Quality Control Report

Consultant **Wahib Medanat** Consultant Engineers
Site Name **Thahr Al Sarow Basic Boys - Jerash**
Package **Package 2**
Contractor **Dijlah Est. Construction Co.**
Tender No. **10/2019/USAID/SKEP/3/2**

Rep No. **QC-22 18**
Date **17 / 07 / 2022**

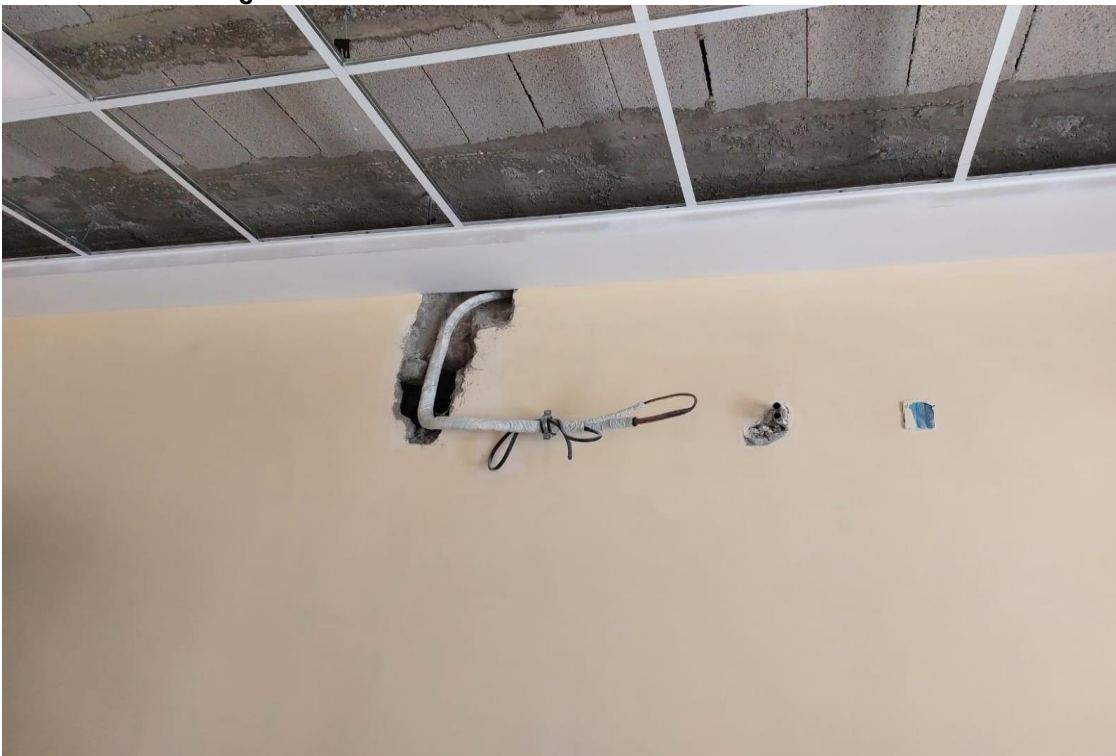
Waving in the painting of the suspended ceilings

Curtain wall is installed completely at the stone

| Description of Non Conformance | Corrective Action | Required by / When |
|---|---|-----------------------------------|
| <ol style="list-style-type: none"> 1. Teething in the built stone at the front façade. 2. Incorrect finish for the door jamb of the multi-purpose hall. 3. Using empty cement bags in the window jamb of the multi-purpose hall. 4. Dimensions of the vision panel of the wooden doors are less than specified. 5. Waving in the painting of the suspended ceilings. 6. Curtain wall is installed completely at the stone. 7. Defects in the cutting of laminated sheet and beech wood frame of the doors. 8. Installing suspended ceiling frame before compeling the mechanical piping in the walls and finishing around them. 9. Defects in the level of the stone tiling at the entrance. | <ol style="list-style-type: none"> 1. Rectify. 2. Re-finish. 3. Remove and finsh. 4. Repair. 5. Repair. 6. Rectify. 7. Rectify. 8. Dismantle, repair, re-fix. 9. Repair. | <p>The Contractor/Immediately</p> |
